# RENESAS TECHNICAL UPDATE

Product Category	LCD driver		Document No.	TN-PLC-A005A/E	Rev.	1.00
Title	Supplementary explanation on deep-standby cancellation sequence		Information Category	Technical Notification		
Applicable Product	R63400, 61503A, R61503B, R61508, R61507, R61509, R61504, HD66781, HD66781S		Lot No.	Reference Document		
			All

**Figure 1** Signal input timings when canceling deep-standby mode (16 bit interface mode)

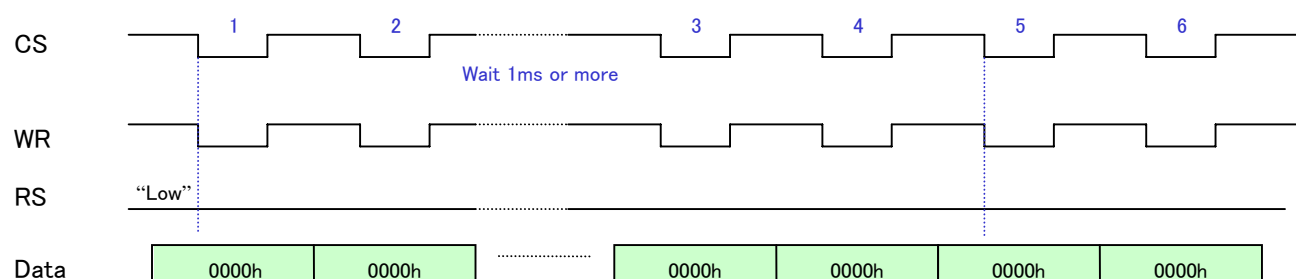
### (1) 16-/18- bit interface mode

Cancel deep-standby mode by writing index data of “0000h” six times when RS signal is “Low”. Wait 1ms or more between 2<sup>nd</sup> and 3<sup>rd</sup> index write.

**Figure 3** Signal input timings when canceling deep-standby mode (8 bit interface mode)

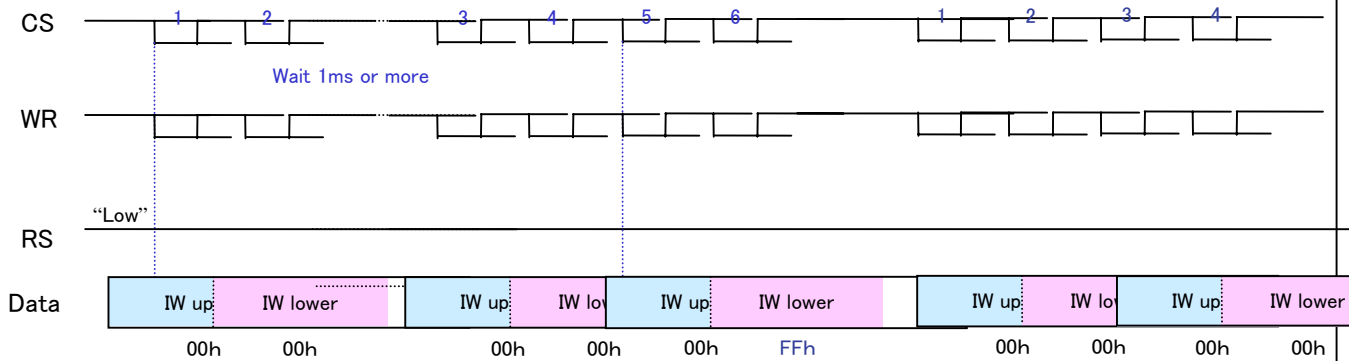
**(2) 8-/9-bit interface mode**

Cancel deep-standby mode by writing bus data "00h" five times and then writing bus data "FFh" once. Make sure to write in "00h" four times consecutively as the transfer synchronization process. Wait 1ms or more between 2<sup>nd</sup> and 3<sup>rd</sup> write-in operation.
